**From:** [Nicholas Bayley](#)  
**To:** [Mike Domine](#); [Sally Elmiger](#)  
**Cc:** [George Tsakoff](#)  
**Subject:** Northville, Foundry Flask Development, Driveway Alignment, Cady ROW Dedication  
**Date:** Tuesday, September 21, 2021 4:26:08 PM  
**Attachments:** [image001.png](#)  
[image002.png](#)

Re: 456 Cady Street – Preliminary Site Plan Review  
OHM Job No. 0152-21-1030

**Re:** Northville 456 Cady Foundry Flask  
Traffic Impact Study Review

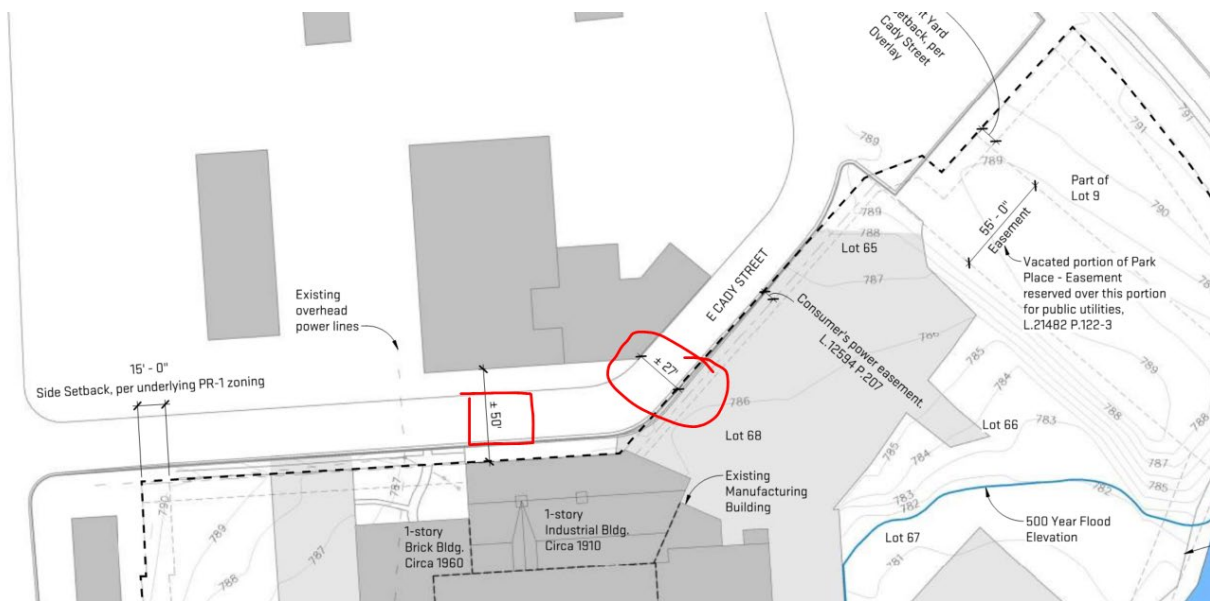
We have done a quick review of the proposed driveway as provided in the cover sheet of the preliminary site plan sheets dated 7-8-21.

The alignment of the proposed driveway as compared to the existing driveway approach a 361 Cady is in a preferred offset so that apposing left hand turning movements do not conflict. We know thru a recent utility plan meeting with Mike and SKE that the Foundry Flask proposed building foot print has shifted to the west to provide separation from the existing WM and Sanitary Sewers which are at the edge of the property line. We have not received plans that reflect that change so the driveway alignment reviews might not be the latest version. Our traffic department will do a more thorough review and provide comments at the end of the week. The offset could be a contingency item for PSP approval " Driveway location may need to be optimized based on future traffic engineering review".

Also we would ask that a full 50 ft right of way past the bend, or (25 ft from Center Line, 50%) be obtained from the applicant to be dedicated as Cady ROW. Per our Utility meeting and subsequent utility needs review Northville would benefit from replacing the sanitary sewer along Cady along with the already planned WM replacement and these efforts will be less costly to construct if the contractor has as much space to work in as possible and a reasonable distance from the existing building foundation. There is also an ELGE requirement of new utilities to maintain a minimum of 10 ft horizontal separation, which would also be easier to do with more total ROW. I don't know if this has previously been requested of the applicant or how this has been handled thru the Cady Street Overlay (CSO) District, planning documents, but I wanted to bring this up now so that hopefully it can be incorporated into the plan. I know at the Pre-application meeting there was some discussion with SKE and the applicant about providing an easement (sidewalk) up to the face of the building from the ex ROW but that can't be used for Utilities and is less desirable than a full dedicated Cady ROW.
